April 11, 2022

Mr. Doug Baines  
Chair  
Elm Creek Watershed Management Commission  
3235 Fernbrook Lane  
Plymouth, MN 55447

**Subject:** Proposed rules revisions regarding low floor/freeboard

**Subject:** 2022 Rules and Standards Minor Plan Amendment

Exhibit A shows a diagram of the proposed freeboard requirements.

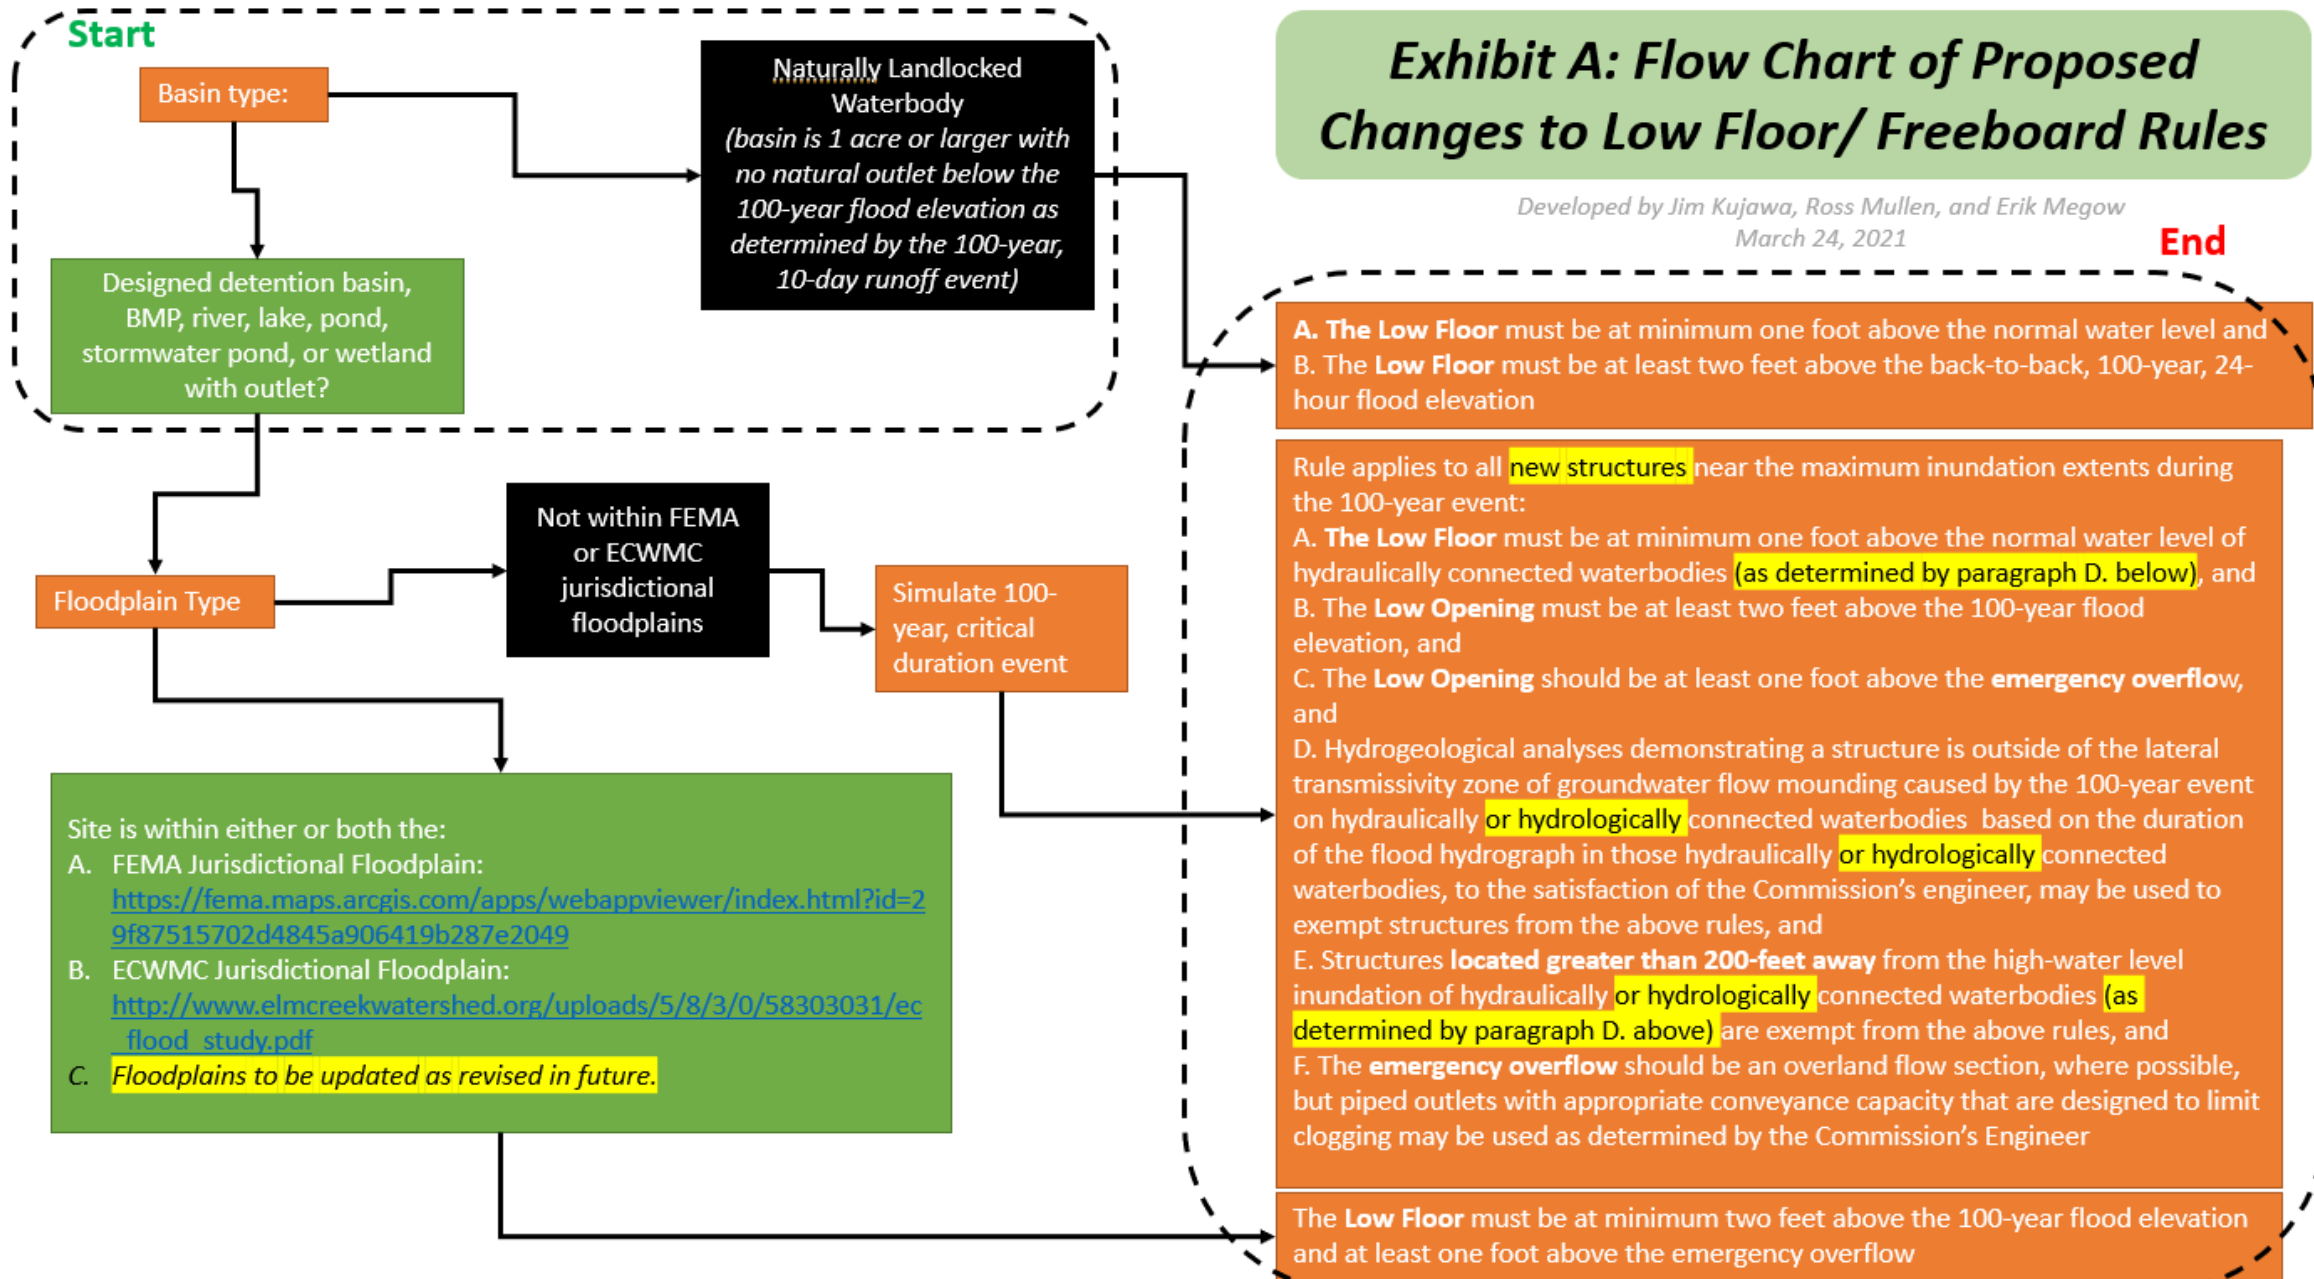
The Commission's technical staff and TAC have determined that transition from the existing rules to a three-tiered approach based on the unique flood risk posed to structures based on the flooding source without over complication of the ECWMC's rules.

The Commission's technical staff and TAC recommend the tiered approach to recognize the differences in flood risk from large waterbodies that may have flood stages that last weeks or months from those of small stormwater ponds and waterbodies where the flood stages last hours or days. The flood risk, especially that caused by groundwater sources, is significantly lower to structures surrounding these small stormwater ponds and waterbodies.

- b. Proposed: *“Structures shall be elevated according to the following criteria based on the flooding source.*
    - i. *Structures that are within the closed basin of naturally landlocked waterbodies and outside of the effective Federal Emergency Management Agency floodplain as shown on the Flood Insurance Rate Map and outside of the Commission’s floodplain shall meet the following criteria:*

1. *The low floor must be at minimum one foot above the normal water level and*
      2. *The low floor must be at least two feet above the back-to-back 100-year 24-hour flood elevation.*

- ii. *Structures within the proposed Federal Emergency Management Agency and/or within the Commission’s floodplain (excluding FEMA Zone A areas) shall meet the following criteria:*

1. *The Low Floor must be at minimum two feet above the 100-year flood elevation and at least one foot above the emergency overflow.*
    - iii. *Structures that are within the closed basin of naturally landlocked waterbodies and the Federal Emergency Management Agency and/or Commission’s floodplain shall have a low floor elevation at whichever elevation highest elevation calculated from the following:*

1. *The low floor must be at minimum one foot above the normal water level and*
      2. *The low floor must be at least two feet above the back-to-back 100-year 24-hour flood elevation.*

3. *The low floor must be at minimum two feet above the 100-year flood elevation.*
    - iv. *Structures near the maximum inundation extents caused during the high-water level of nearby stormwater ponds and/or waterbodies that are outside of a naturally landlocked waterbody basin, Federal Emergency Management Agency floodplain, and the Commission’s floodplain shall meet the following criteria:*

1. *The Low Floor must be at minimum one foot above the normal water level of hydraulically or hydrologically connected waterbodies (as determined by paragraph d. below) and*

2. *The Low Opening must be at least two feet above the 100-year flood elevation and*
  3. *The Low Opening should be at least one foot above the emergency overflow and*

4. *Hydrogeological analyses demonstrating a structure is outside of the lateral transmissivity zone of groundwater flow mounding caused by the 100-year event on hydraulically or hydrologically connected waterbodies and based on the duration of the flood hydrograph in those hydraulically or hydrologically connected waterbodies, to the satisfaction of the Commission's engineer, may be used to exempt structures from the above rules.*

5. *Structures located greater than 200-feet away from the high- water level inundation of hydraulically or hydrologically connected waterbodies (as determined by paragraph d. above) are exempt from the above rules.*
